MANDATORY SERVICE BULLETIN

NUMBER: SB-032
REVISION: A
DATE: 10/26/2010

SUBJECT: NOSE WHEEL STEERING, Mandatory Steering Bungee Inspection and Modification

KODIAK 100 Series Aircraft Serial Numbers:
• **100-0001 through 100-0044**

Figure 1: Steering Bungee Inspection Location

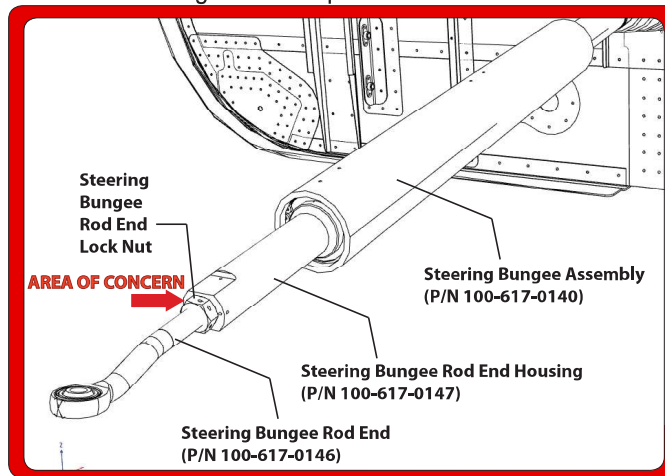
Quest Aircraft Company has received a single report that during a maintenance inspection of a KODIAK 100, excessive movement and play was found between the Steering Bungee Rod End Housing (P/N 100-617-0147) and the Steering Bungee Rod End (P/N 100-617-0146) with the Lock nut tightened to specifications.

Quest Aircraft Company is mandating a one-time inspection and modification to check the Steering Bungee (P/N 100-617-0140) for movement in the area where the Steering Bungee Rod End Housing (P/N 100-617-0147) connects to the Steering Bungee Rod End (P/N 100-617-0146) (See Figure 1). The Steering Bungee modification (FSI-018) consists of installation of a Locking End Cap to the Steering Bungee.

2. Inspect the Steering Bungee assembly (P/N 100-617-0140) for movement in the area where the Steering Bungee Rod End Housing (P/N 100-617-0147) connects to the Steering Bungee Rod End (P/N 100-617-0146) (See **Figure 1**):

- a. Manually move the Steering Bungee in all directions at the area of concern noted in **Figure 1**. Observe for movement between the Steering Bungee Rod End Housing (P/N 100-617-0147) and the Steering Bungee Rod End (P/N 100-617-0146). There should be no relative movement between the two. If movement is found, the Steering Bungee Rod End Lock Nut should be verified for proper torque (reference the KODIAK 100 Maintenance Manual, 180-200 in-lbs). If relative movement is still found, contact Quest Aircraft for a replacement Steering Bungee assembly.

1. Once **Section 1** is complete, perform the instructions in **FSI-018** to modify the Steering Bungee within the time frame listed in the Compliance Section on **Page 1**. This modification installs a Locking End Cap to the Steering Bungee Rod End (P/N 100-617-0146) assembly.
